Re: Further Information Request, s92 Response – McPherson Quarry, Mangawhiri

This letter has been prepared in response to a request for additional information prepared by O. May - Boffa Miskell (18 December 2019) and an email from V. Majoor – Waikato District Council, on behalf of the Waikato District Council.

VIEW LOCATION SEVEN - PROPOSED STAGE 3 VIEW LOOKING EAST FROM MT WILLIAM (WITH MITIGATION PLANTING)

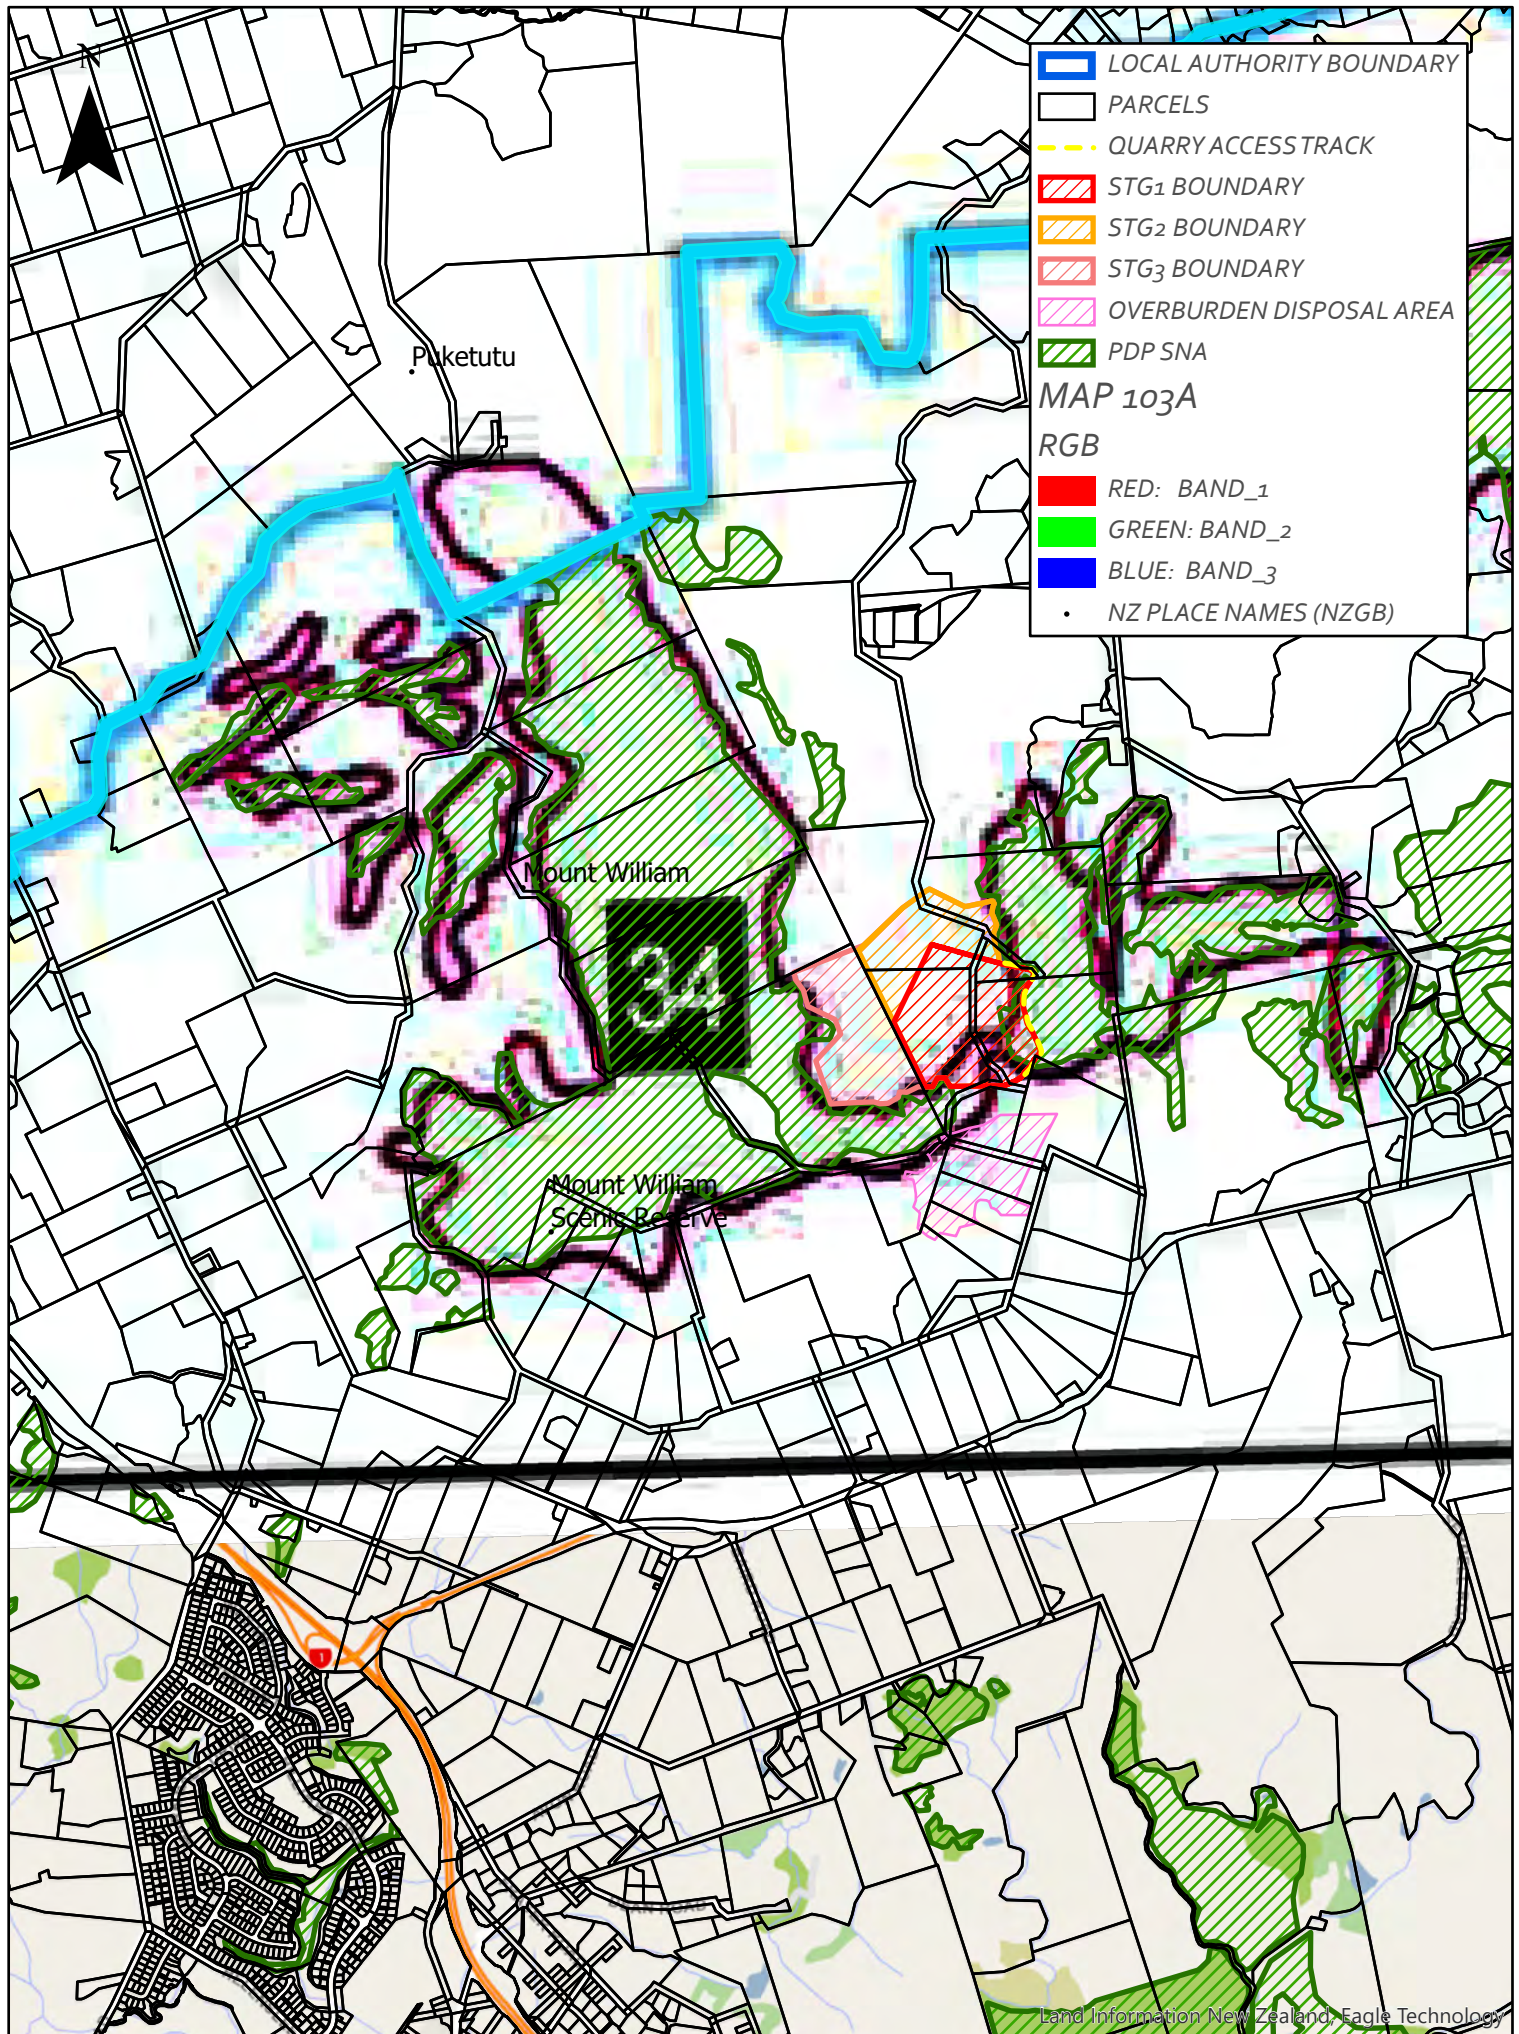
- *Has the Overburden Disposal Area (ODA) been modelled in the Visual Simulation? The ODA is described as partially visible in the assessment but cannot be seen in the Visual Simulation.*

- *Is it concluded that the overall visual effects will be less than minor, as concluded in the Opus assessment? The increased level of effects experienced in the VP4, VP6 and VP7 to moderate and high would suggest that this may have changed. Could MGLA confirm how the additional viewpoints are considered in the round for the overall conclusions?*

The overburden disposal area (ODA) is not shown in the visual simulation supplied to Council. The layer showing this aspect was accidentally left switched off on the proposed montages. This has been corrected in the attached montages.

It should be noted that the visual simulations represent the end of each stage of extraction (i.e. completed pit and overburden disposal). Because overburden stripping and disposal will occur at the beginning of each stage, the ODA will be at a point where it already has been filled and regressed. During overburden stripping and placement, a small portion of the overburden stockpile area will be exposed to view while

While the ODA was not shown within the original visual simulation (s92 report - MGLA), the effects and overall findings will not change. The effects of the overburden disposal area along with the effects of the quarry pit was included and taken into consideration in every aspect of the previous report.

As identified in the s92 response, the overall adverse effects ratings will range between *Negligible* and *Low-Moderate* for stage 1, *Very Low* and *Moderate* for stage 2 and *Negligible* and *High* for stage 3. The overall effects therefore range between *Negligible-Very Low* and *High*. While the averaging of overall assessment ratings must be considered with caution (due to the potential for the type and level of effects to differ from location to location), in the round, the overall effect of the proposal on the wider landscape is considered to be *Low-Moderate*. This is equal to the *minor* threshold of the RMA.
